2. Procedure for removing motor support:

3. Procedure for fixing motor support on bogie transom (4 Nos.):

Fig -3

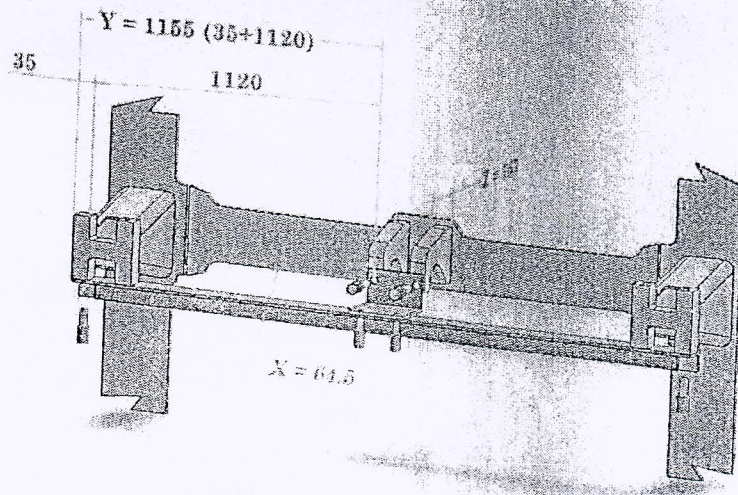
> Finished modified two nos. motor support to CLW drawing No. 1209-01-412-186 will be tack welded in middle of frame using tack welding fixture maintaining distance shown in Fig- 3.

1. X dir. 64.5 mm
2. Y dir. 1155 mm (35+1120)
3. Z dir. 163 mm
4. Sequential Mig welding will be carried slowly using heavy duty Welding Fixture so that distance is arrested and dimensional accuracy with centre line is maintained in X, Y, Z, direction.
